B.G.A. Technical Committee  
TNS 2/3/82

Part I     Airworthiness "aggro"     (Please add to the 1982 Blue pages).

TNS / 3/82.AD/31-265 / JANUARY 21-82Mailed to OWNERS 23/2/82.Subject :

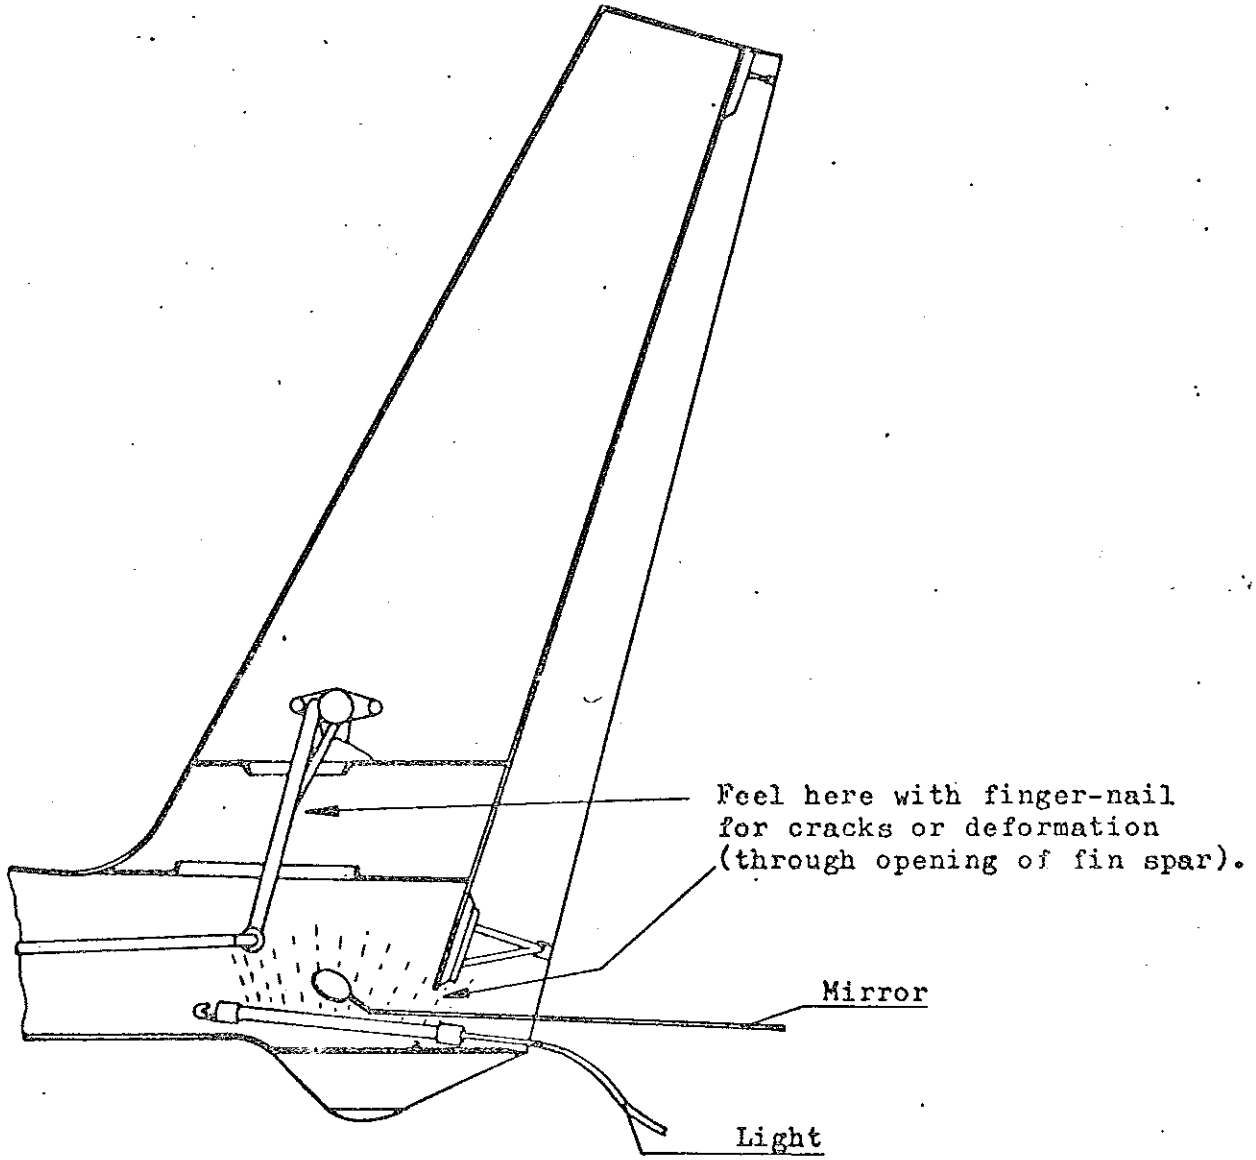
With an ASW 15 the bellcrank actuating the elevator failed in flight (see attached sketch). Luckily the pilot could save himself by parachute. An inspection of the bellcrank showed that an older crack most likely caused by a hard landing some years ago resulted in fatigue failure of the bellcrank.

1. The elevator actuator bellcrank must be inspected for cracks. To do so the rudder has to be disconnected from the fin, as the inspection is possible through a hole of the fin spar (see attached sketch). The inspection area is not directly visible. However, with the finger-nail a major crack can be felt. Smaller cracks may be found by using a mirror and a small light which is fixed to a small strip of wood or a piece of wire.  
If no cracks are found, the rudder can be rigged again to the fin and safetied.
2. If cracks are found, the bellcrank must be exchanged against a new one, i.e. a bellcrank according to drawing 151.35.1011 (showing the correction note "TM 21 dated 24-11-81"). For carrying out this job the Repair Instruction "A" for the ASW 15 is to be used.
3. A copy of the inspection report must be sent to the manufacturer.

If a new bellcrank is installed as mentioned under point 3 of the section "Instructions", it is recommended to install simultaneously the stronger plywood stiffeners of the ASW 15 B (see Repair Instruction "A").

For this Technical Note 21 the drawings 150/151.34 M.11 \* been corrected and marked with the correction note "TM 21 dated 24-11-81".

DIAGRAMATIC VIEWS LOOKING DOWN ON THE REAR TOP OF THE FIN  
BEFORE AND AFTER REPAIR

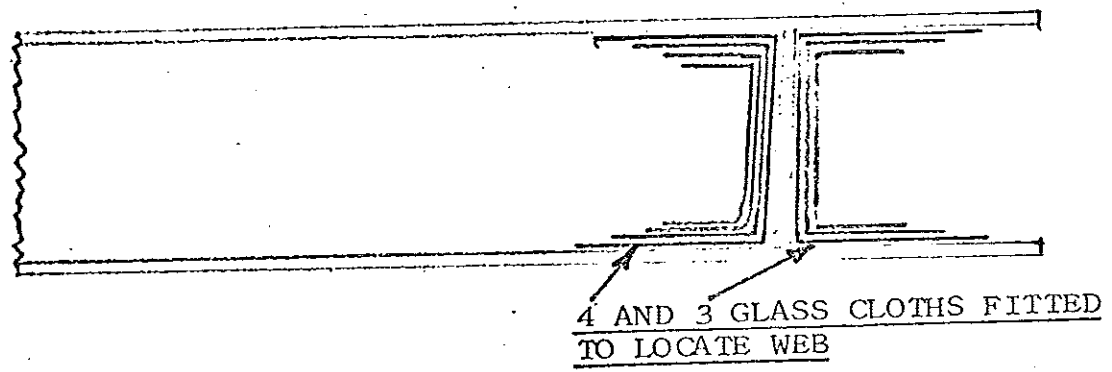
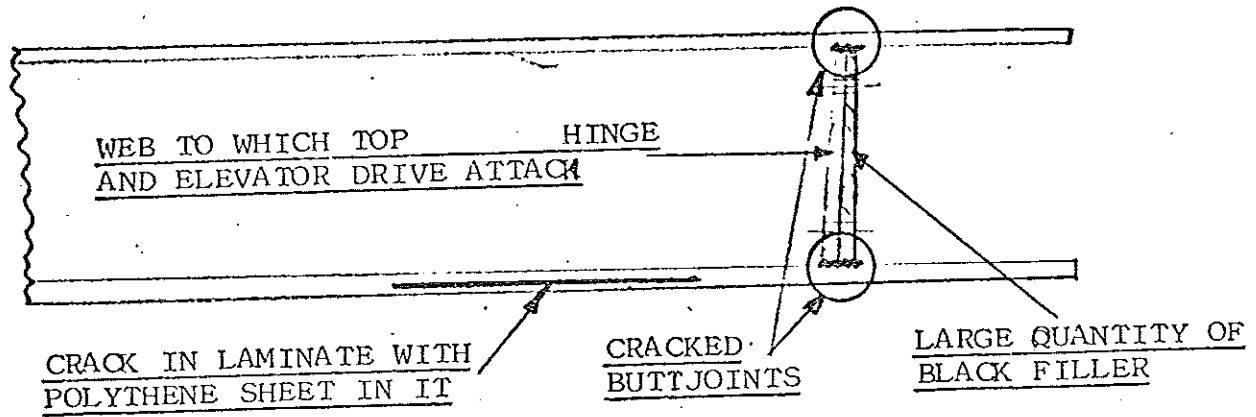
- 1.6     VEGA (T.65). Fin spar carrying Rudder hinge and elevator drive, detached from skin. (Reported by Tim Macfadyen - (Sketch attached) and reported to Slingsby Engineering).

The web to which the top rudder hinge and elevator drive are bolted was cracked from the fin sides. A quantity of filler was removed from its rear face, the area cleaned up, and 7 laminates of 10<sup>02</sup> (INTERGLASS 9215) bidirectional cloth layed on at 45°. The bolt holes were re-drilled and all was reassembled with filler to correctly position the fitting.

A 1" x 3" piece of polythene was removed from the centre of the fin laminate, see sketch. The crack was glued up with Epicort/Epicure.

POSITION OF CRACK ON  
BEARING SUPPORT BRACKET ON FUSELAGE  
OF KA 86 BGA 2083

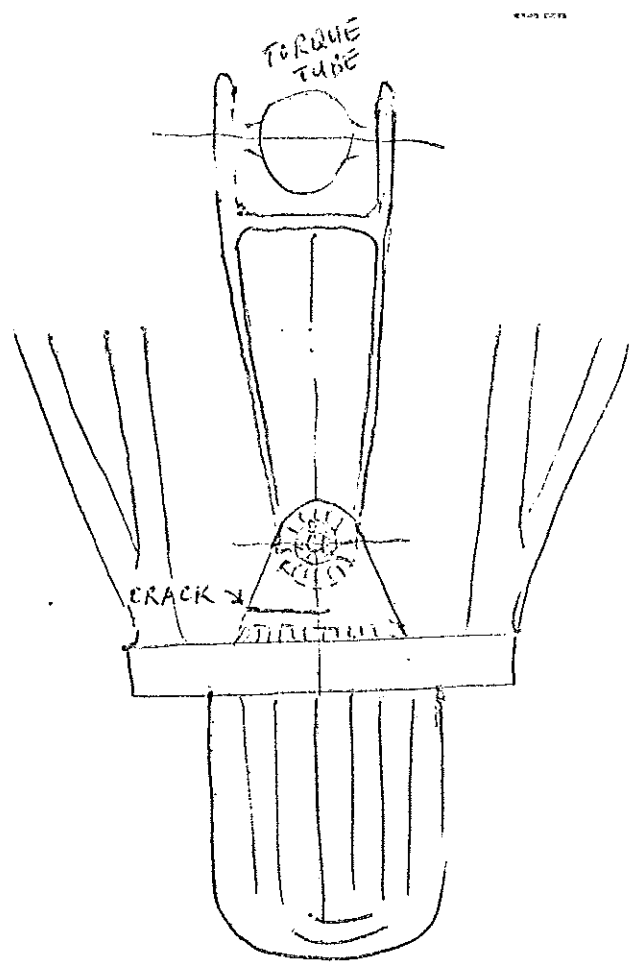
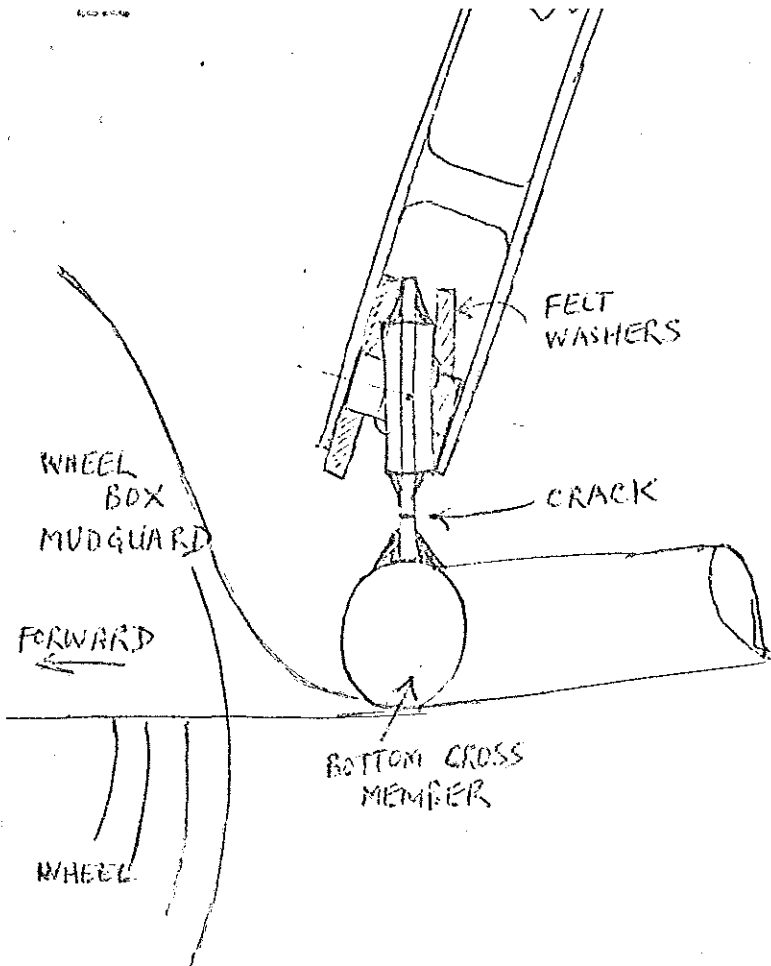
- 1.7     KA 8 - Control Bracket mounting in centre section (Sketch attached), cracked. Repair by Welding. (Reported by R. Jarvis S.G.C.)
- 1.8     ASW 15 & 15B. Elevator Actuator Bell-crank possible fatigue-failure in flight. Copy herewith and mailed to owners. Inspect/Replace as required.
